# TOWN OF GLASTONBURY

## CIDER MILL PUMP STATION UPGRADE

ADDENDUM NO. 1

February 22, 2019

**ROADWAY/DRIVEWAY PAVEMENT**

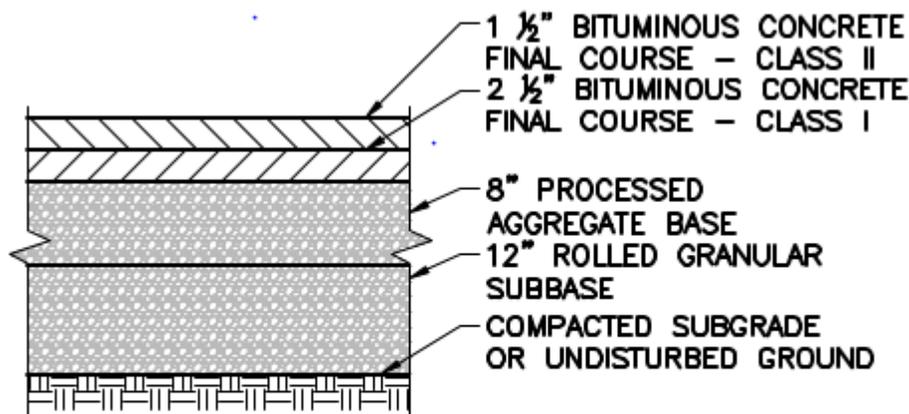
1. **DELETE** the callout "6' HIGH BLACK ALUMINUM FENCE..." and **REPLACE** with "5' HIGH BLACK ALUMINUM FENCE...".
2. **ADD** the following detail to DWG C-4 for roadway paving requirements. In addition, refer to Specifications Section 02513, Bituminous Concrete Paving.

**Question 1:** *Drawing C-2 Demolition Note #4 – Remove and Demolish existing asphalt. Refer to Pavement Details on C-4. There are only pavement trenching details shown on this drawing. Please provide pavement detail.*

**Answer:** A pavement detail has been added by and is included in this addendum.
